DUNE-SP

Technical Integration

- Proposed SHV Panel for DUNE
- APA / TPC CE Interface: 8760450

June 4, 2020

protoDUNE SHV Panel

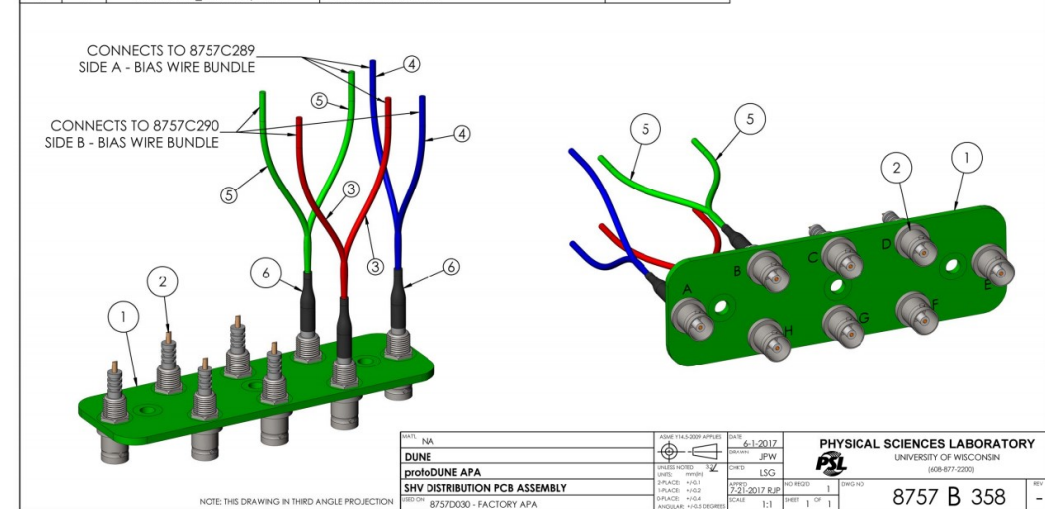
- 1/8" thick G10/FR4
- Eight connectors
- Fastened to the head tube at three locations. 40mm standoffs
- Access to connectors (3" protoDUNE APA frame) was not plentiful
- Referring to this as a PCB is not technically true

Proposed SHV Design for DUNE (1/3)

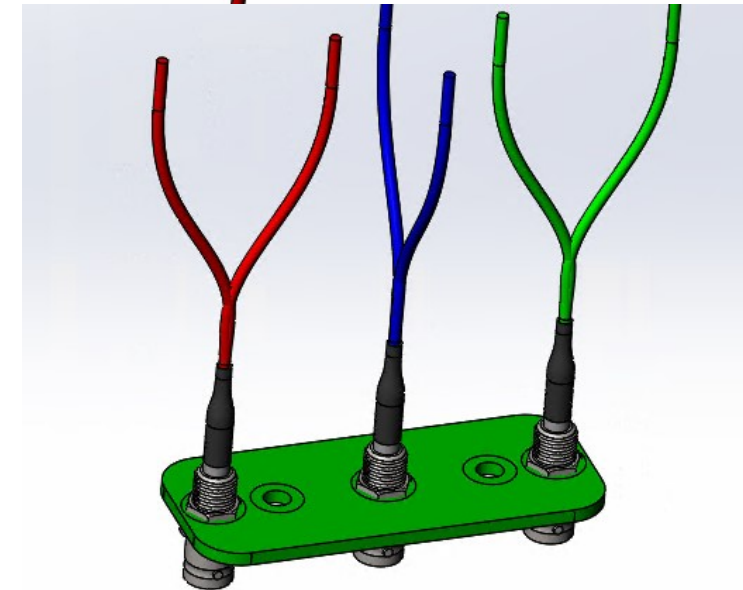
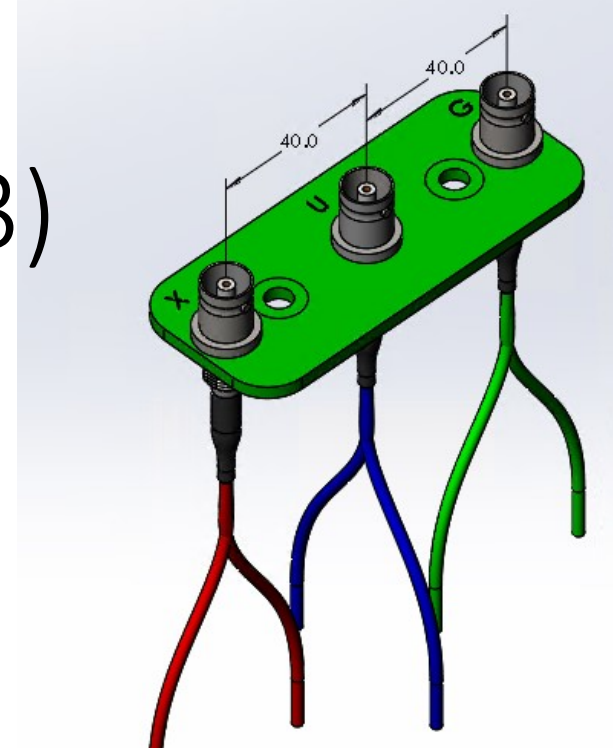
- Maintain material and thickness
- Reduce connector quantity to three
 - X, U, G
 - No FC Terminations board on APA
 - No active diverters
- Increase the spacing between connectors
- All connectors in line and centered between CE boxes
- Two connections to the head tube (reduced from three)
 - Shift the board away from PD cable pass through
- Move SHV board closer to the high slot side tube to facilitate distribution of cables
- Optimize the height of the standoffs (away from head tube)
 - Work with CE (Thanks, Manhong)
- Everything above **does not** require changes to the head tube
